**IEEE 802.16 Presentation Submission Template (Rev. 9)**

Document Number: IEEE S802.16maint-08/261

For discussion and approval by IEEE802.16 Maintenance TG

## Problem Statement: 16e UL PUSC MIMO-CSM Tile

## ➤ New UL PUSC MIMO-CSM Tile

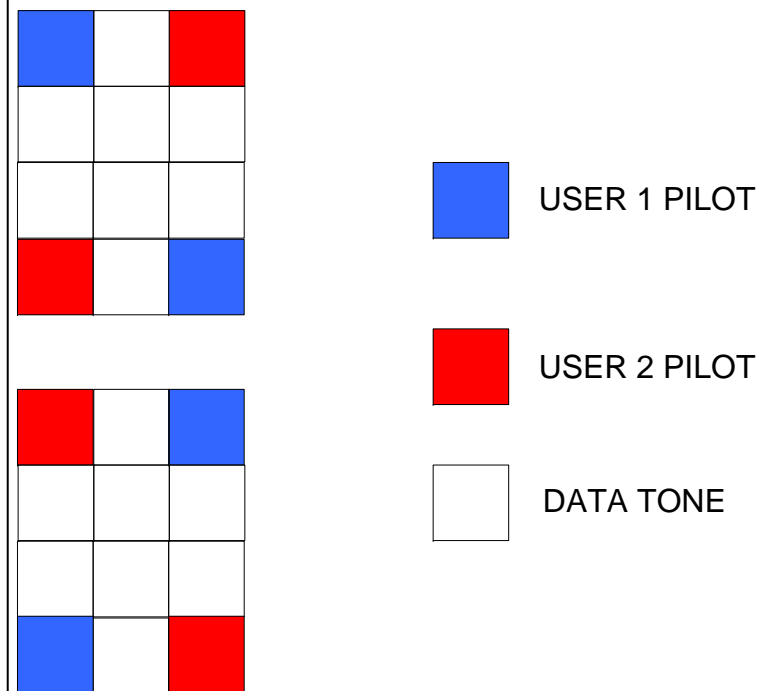
- Pilots of Users 1 and 2 are rotated along the tiles of a sub-channel

- The rotating pilot structure along tiles of a sub-channel are used to separate the phase contribution due timing offset ( $\theta_t$ ) from the phase contribution due to frequency offset ( $\theta_f$ ) by creating two independent equations with the two unknowns
- Examine the following two equations generated by two vertical tiles in the same sub-channel (tiles  $p$  and  $p+1$ ) for a given antenna
